The Secretary
NSW Planning, Industry & Environment

I refer to the Department's below email of 11 3 January May 2021 regarding the public exhibition of the Environmental Impact Statement (EIS) for State Significant Development SSD-10457 Concept Plan proposal for a retail outlet centre on Lot 3 at the Eastern Creek Business Hub at Rooty Hill Road South, Eastern Creek (Lots 1 & 13 DP 1258787; Lots 1, 3 & 4 Sec B DP 8681; Lot 3 DP 830836), including food and drink premises, an indoor recreation facility and Stage 1 early works. Submissions need to be made to the Department by 10 March 2021.

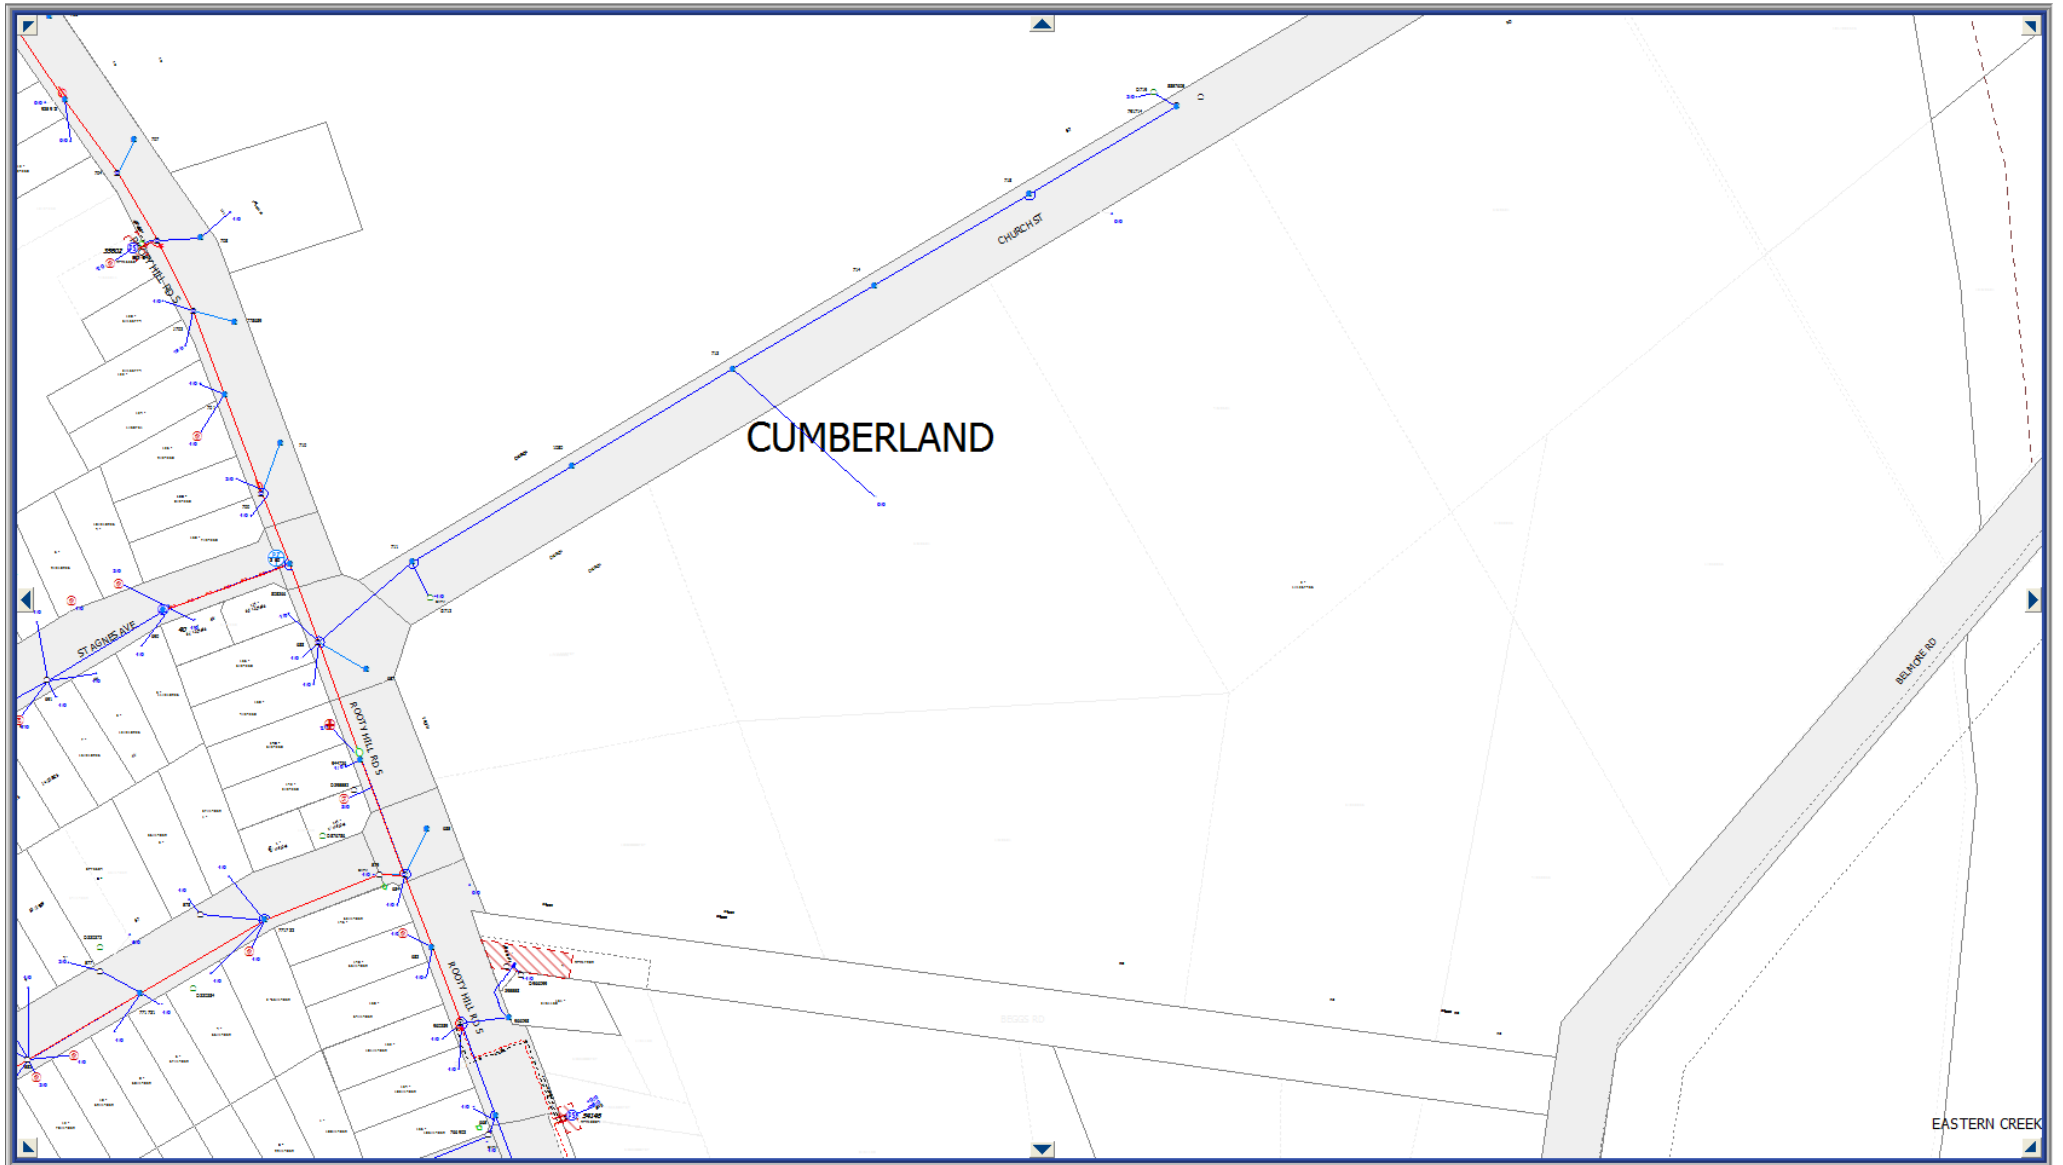
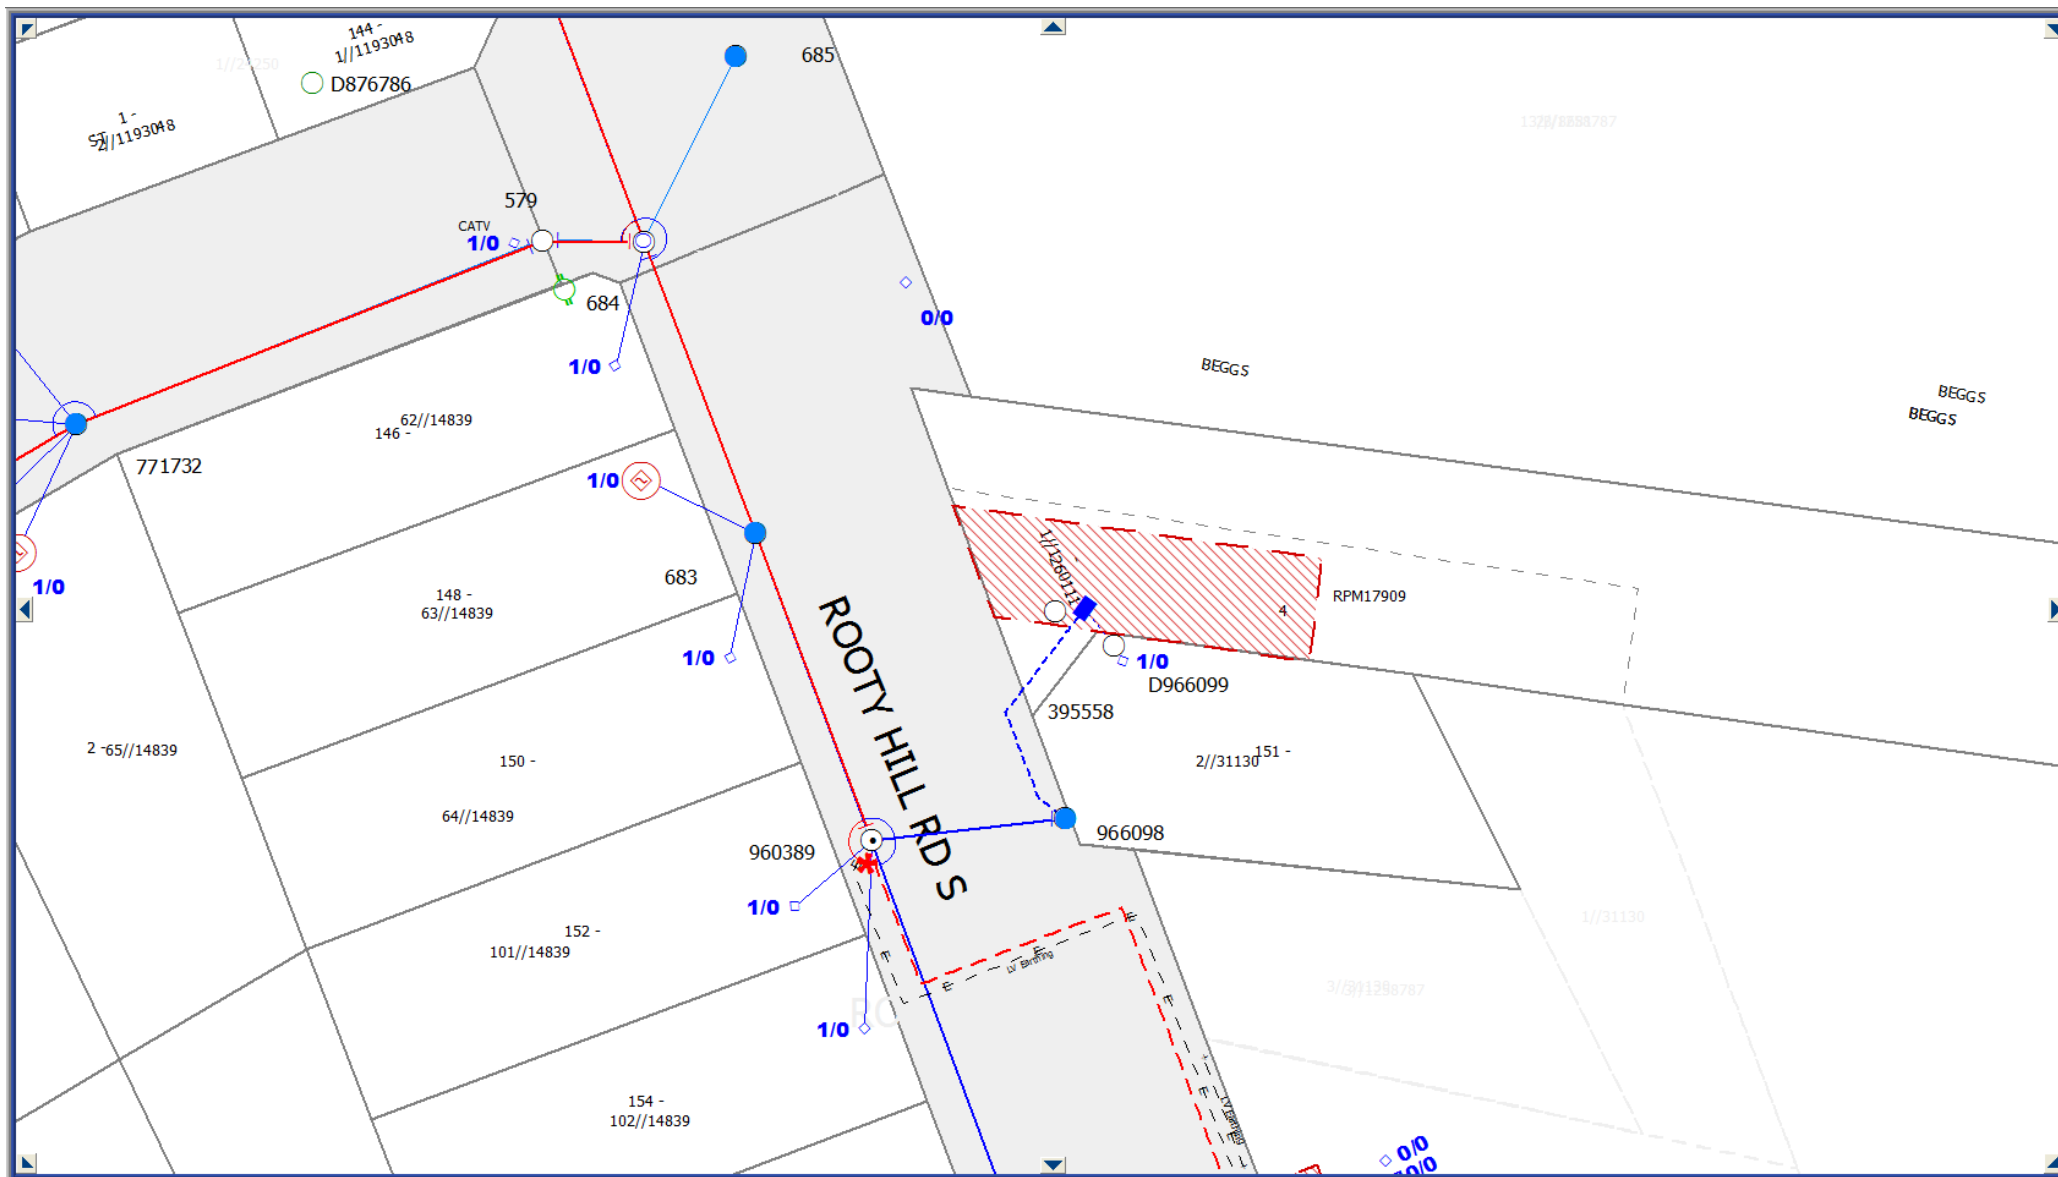
In regard to the road closure of the former Beggs Road reserve, which is shown in the below updated site plan from Endeavour Energy's G/Net master facility model and as shown in the following extract of DP 1260111, there is an easement benefitting Endeavour Energy for overhead power lines. It also indicates that whilst the poles are still in place, the former low voltage overhead power lines have been undergrounded and there is now a low voltage pillar (indicated by the blue rectangle ) from which customer connection points are provided. This easement is likely to be released once the truck turning area within Lot 2 is completed. In the interim, except for any approved / certified works by Endeavour Energy's Network Connections Branch as part of an enquiry / application for load or asset relocation project, the easement must be managed in accordance with the attached copy of memorandum for the AK104602.
